CITY OF MASSILLON, OHIO.	
17TH ST. NE PAVING	
From Lincoln Way East to Sippo Creek	
Approved City Engineer	DEPT. OF PUBLIC SERVICE ENGINEERING DIVISION
Drawn by T.R. CER-GW	Scale 1" = 50' Horiz 1" = 5' Vert
Jan. 11 1939	NB 111- P. 55 665

SHEET #2
CITY OF MASSILLON OHIO
17TH ST. N.E. PAVING
SEWARD CREEK TO LINDBERGH
 APPROVED: [Signature] CITY ENGINEER
 DEPT. OF PUBLIC SERVICE
 PREPARED BY: [Signature] CIVIL ENGINEER

CITY OF MASSILLON OHIO
17TH ST N.E. PAVING
SIPPO CREEK TO LIN WAY E

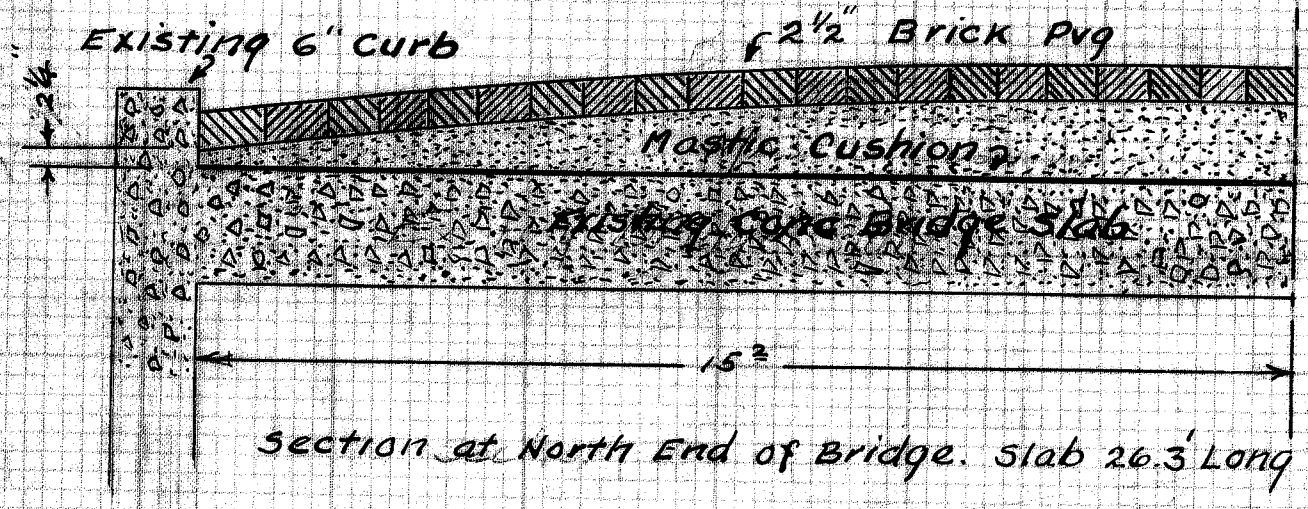
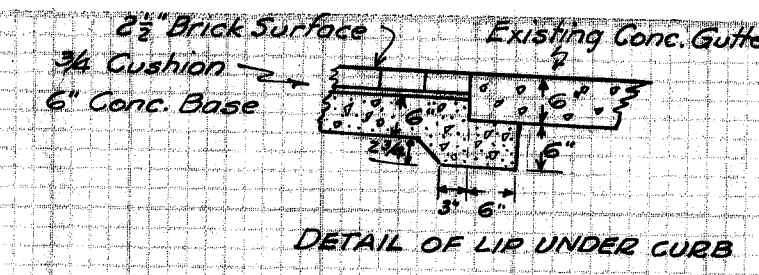
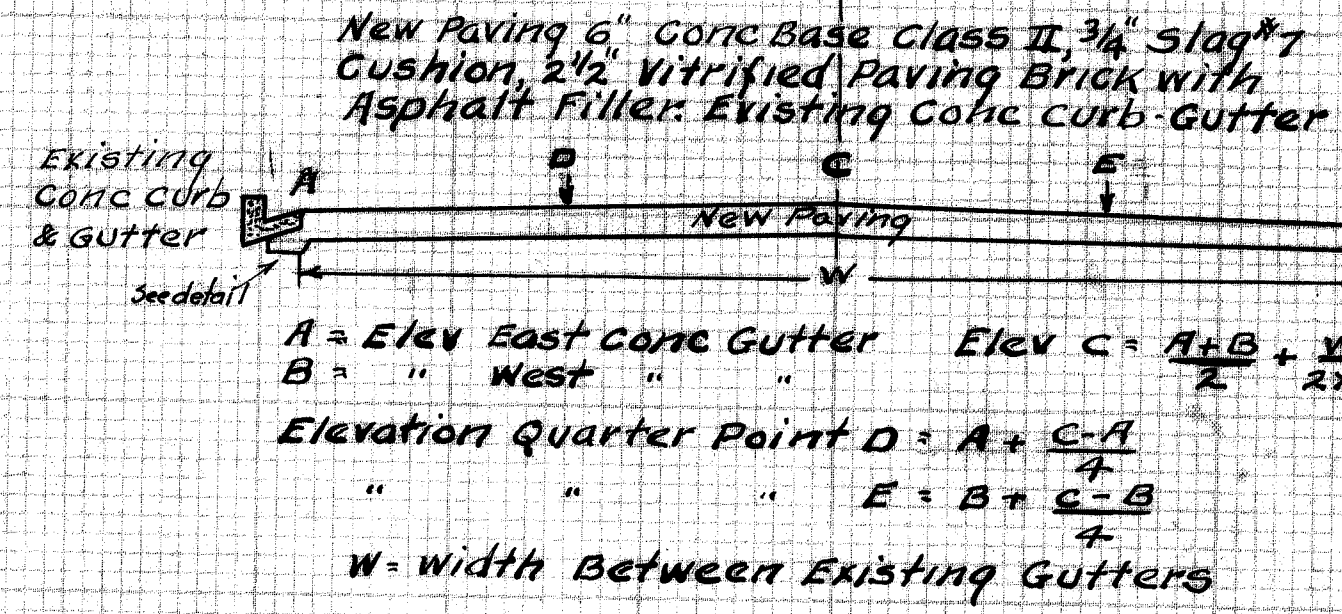
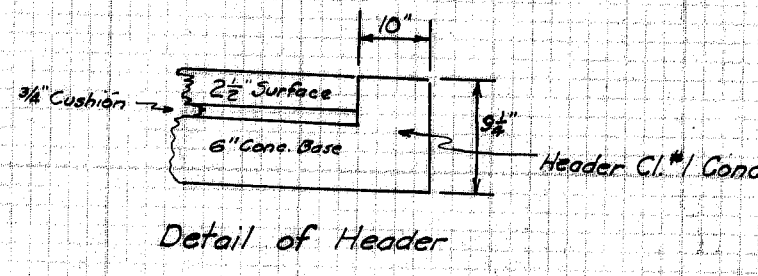
Curb and walk to be adjusted
 to meet gutter line elevation from
 sta. 1+111 to 1+50±, East side

Stoner Ave NE change curb returns from
 34.0 feet to 24.0, try and move old circles
 to new location, if not possible put in new
 concrete curbs 16.0 Radius, header to
 be 16.0 back for either way.
